Access Compliance Report Public Rights-of-Way (Curb Ramps)

Main Street: N_SELLAS_RD		Cross Street: AVENDALE_BLV		Location:	NE
ADA ID: RPRK211109131505	Ramp Type: Type 4 - Parallel	Initial Pass/Fail: Fail	Overall Compliance: No	Severity Score:	16

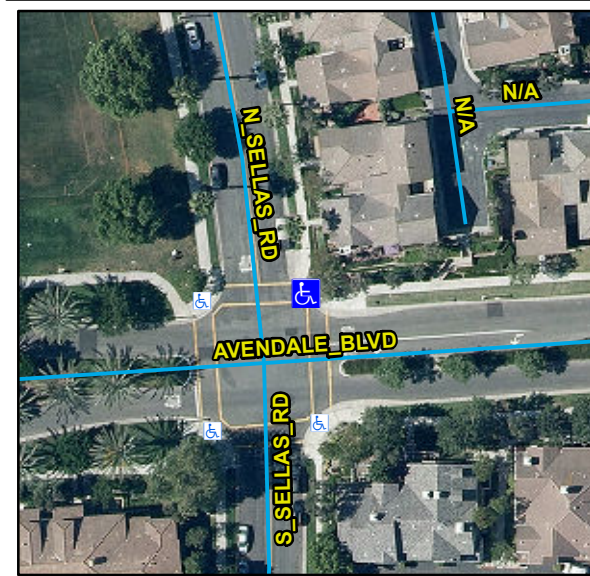
R204.3, R304.5.3, R304.3.2, STD 1115

Remove & Replace Curb Ramp With Two New Directional Ramps or Equivalent.
